# COUNTY OF LOS ANGELES

## DEPARTMENT OF PUBLIC WORKS

January 17, 2008

### **REQUEST FOR PROPOSALS – ADDENDUM 1 VIDEO DISTRIBUTION SYSTEM FOR THE TRAFFIC MANAGEMENT SYSTEM (2007-IT033)**

Figure 1 - The Planned Video Distribution System Architecture

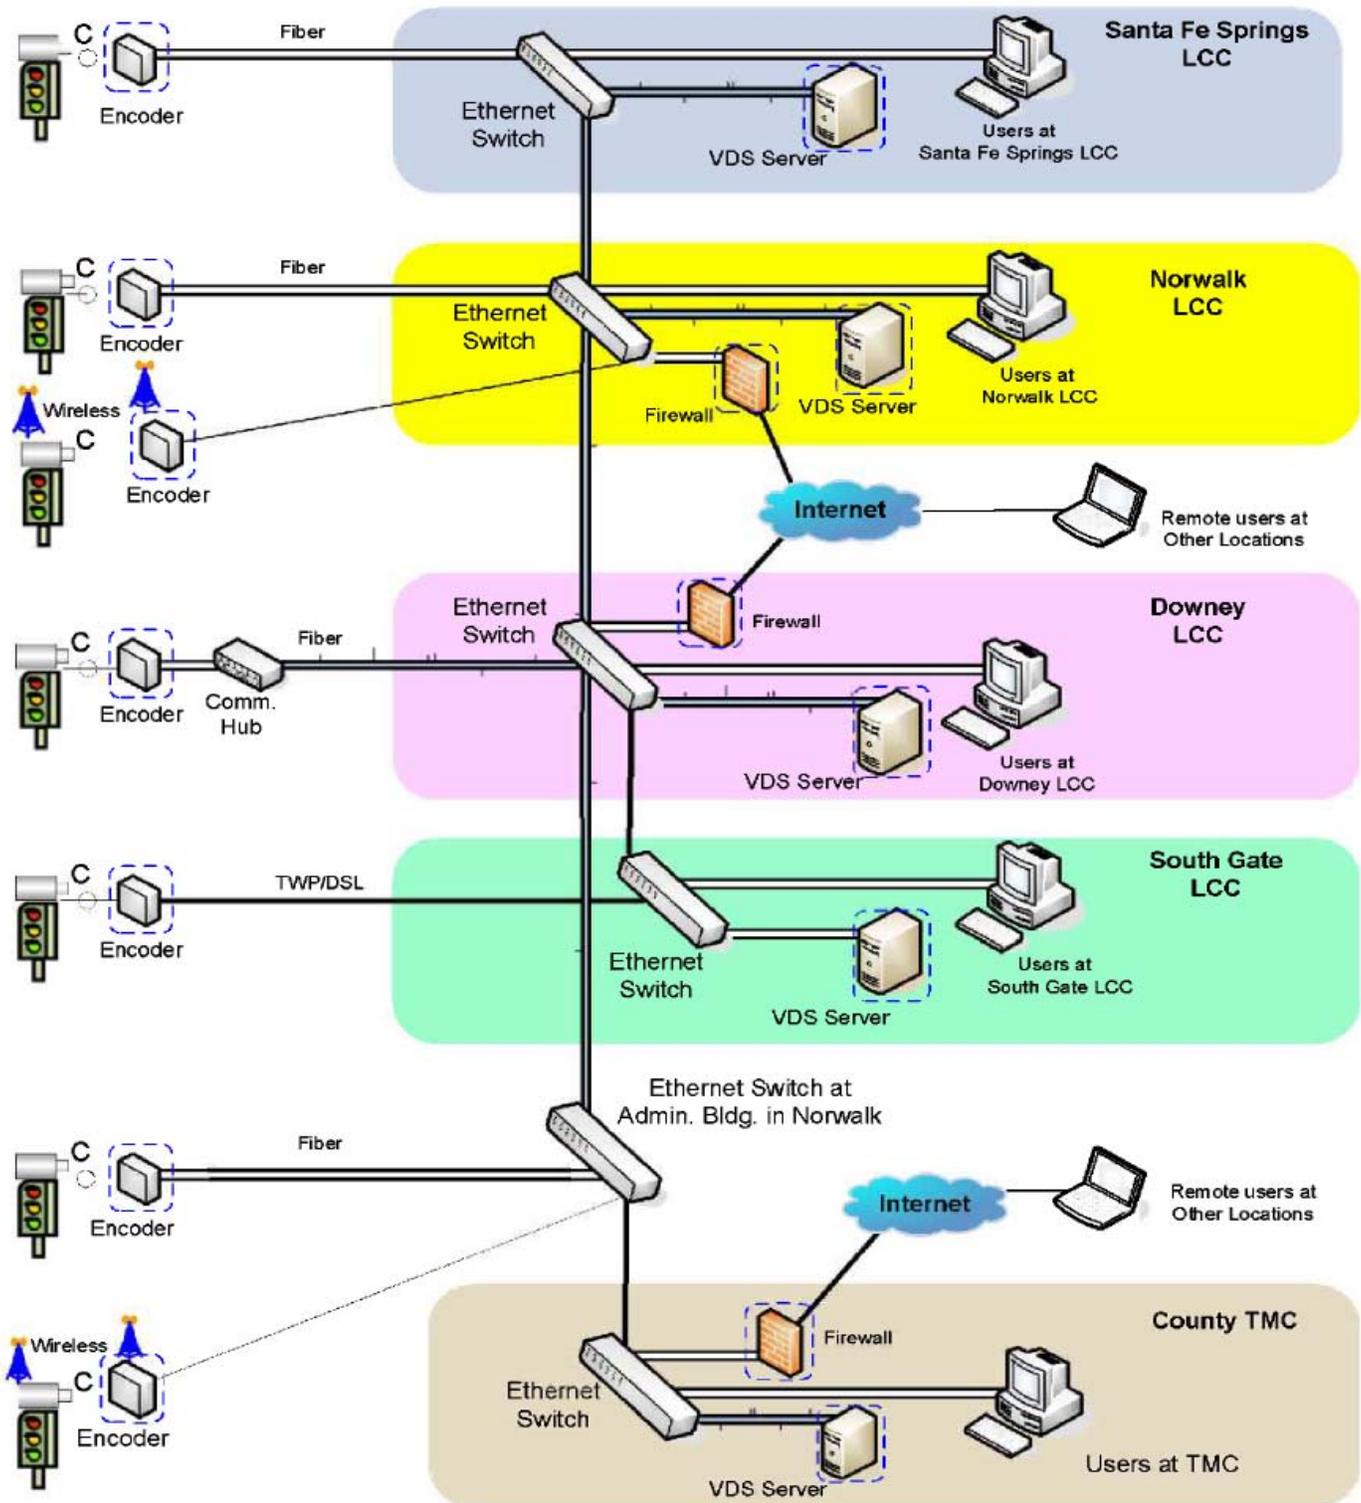
1. Enclosed is a colored copy of Figure 1 – The Planned Video Distribution Architecture (Enclosure D).
2. Form PW-14, Specifications Questionnaire, Technical Specifications section, Item 6; and Exhibit F, Functional Specifications, Technical Specifications section, Item 6:

**Response:** It should be assumed that the bandwidth specifications as noted in Figure 1 - The Planned Video Distribution Architecture diagram are existing or will be accommodated.

**Response:** Yes, Cisco routers and switches will be configured for the existing system or will be installed to support the data lines as detailed in the Figure 1 – The Planned Video Distribution Architecture diagram.
